FAIRBANKS HALL

ADA ASSESSMENT & SURVEY

Re: ADA Accessibility Survey and Assessment – Fairbanks Hall

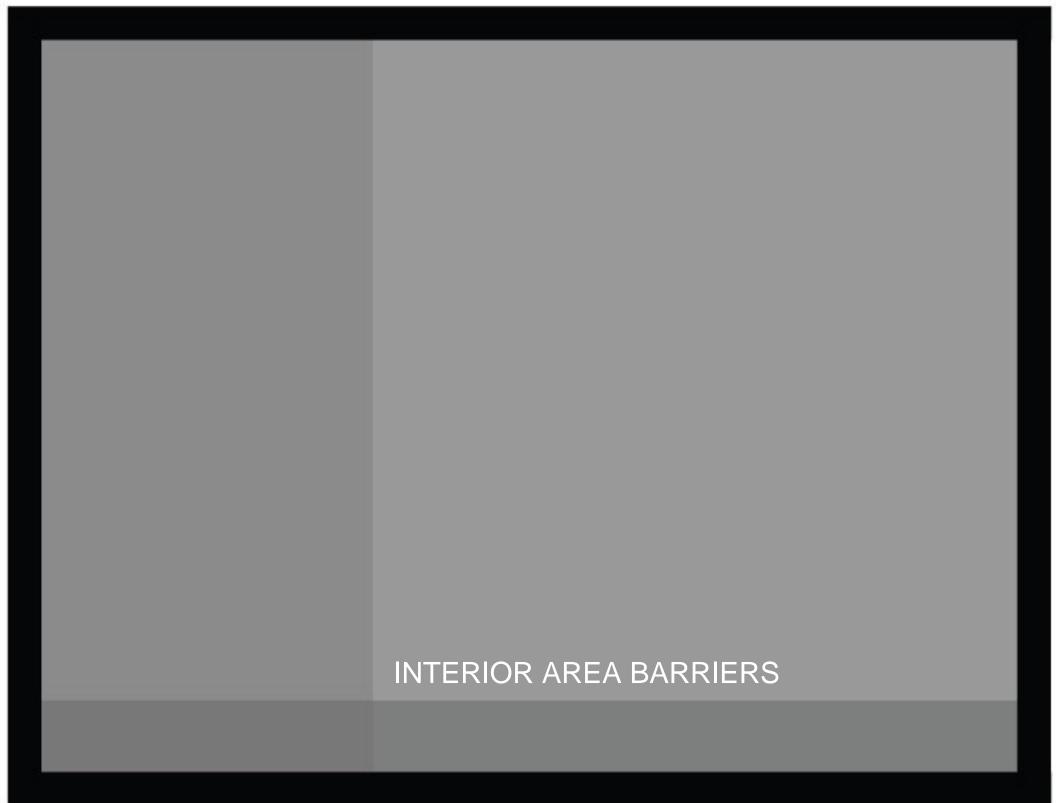
Field Date:	7/15/2011 Report Date 7/15/2011 Barrier #: 2297A
Bldg Name:	Fairbanks - Parking Lot Reference Dwg: 1 of 5
Location:	Exterior - Pathway to Accessible Stall
X Coordinate:	7477575.868 Y Coordinate: 339984.393
Barrier Area:	Ramps
Barrier Type:	Cross Slope - Existing (>5.0% or more)
Code References:	2010 ADAS 405.3
Performance Sta	ndard: No Quantity: LF As-built : 6
Barrier Description:	Cross slope exceeds 2.0% (>5.0% or more)
Findings:	10.6% cross slope at ramp serving accessible parking stall
Rec. Solution:	Demolish existing and construct new ramp
Barrier Severity:	1 Necessary Cost Est \$0.00 Facility Function: Public Status: Open
Implementation	Priority: 1 Implementation Phase: Implementation Date:
Notes:	
Field Date:	7/15/2011 Report Date 7/15/2011 Barrier #: 2297B
Bldg Name:	Fairbanks - Parking Lot Reference Dwg: 1 of 5
Location:	Exterior - Pathway to Accessible Stall
X Coordinate:	7477575.868 Y Coordinate: 339984.393

Barrier Area:	Ramps
Barrier Type:	Running Slope - Existing (8.6% - 8.9%)
Code References:	2010 ADAS 405.3
Performance Sta	ndard: No Quantity: LF As-built : 6
Barrier Description:	Running slope exceeds 8.33% (8.6% - 8.9%)
Findings:	8.9% running slope at ramp serving accessible parking stall
Rec. Solution:	Demolish existing and construct new ramp
Barrier Severity:	3 Hindrance Cost Est \$0.00 Facility Function: Public Status: Open
Implementation	Priority: 1 Implementation Phase: Implementation Date:
Notes:
